Board of Zoning Adjustment
Staff Report
October 1, 2018

Case No:	18CUP1073
Project Name:	Kingdom Center Church
Location:	13913 Poplar Lane
Owner:	James D. & Margie Charasika
Applicant:	The Kingdom Center Church
Representative:	Glenn Price
Jurisdiction:	Louisville Metro
Council District:	#20 – Stuart Benson
Case Manager:	Steve Hendrix, Planning & Design Coordinator

PRELIMINARY ELEVATION

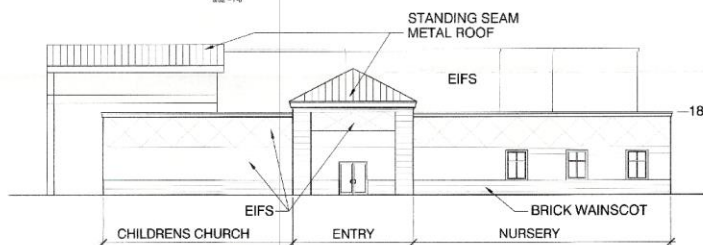
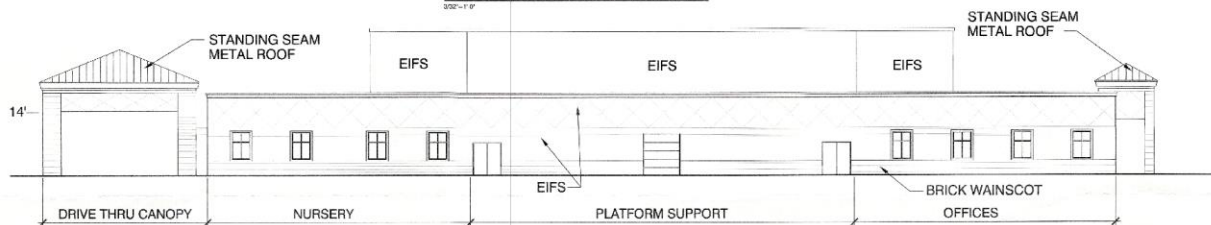
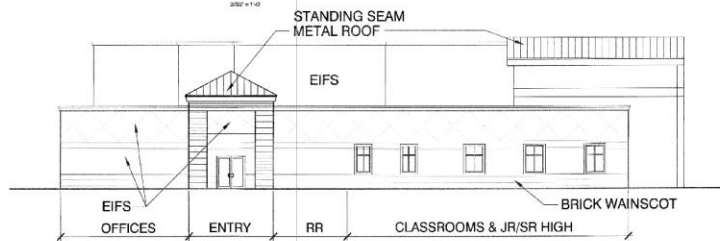
**STANDARD OF REVIEW AND STAFF ANALYSIS FOR VARIANCE of
the Land Development Code, 5.3.1.C.5. to allow the proposed
structure to be 32 feet high.
(30 foot maximum, request of 32 feet, variance of 2 feet).**

STAFF: The variance will not adversely affect the public health, safety or welfare because of the distance from surrounding structures and property lines.

STAFF: The requested variance will not alter the essential character of the general vicinity due to the placement of the church.

STAFF: The requested variance will not cause a hazard or nuisance to the public, since it will not be noticeable.

STAFF: The requested variance will not allow an unreasonable circumvention of the zoning regulations, since churches tend to have a taller height.

STAFF: The strict application of the provisions of the regulation would create an unnecessary hardship, since the building's design would have to be changed.
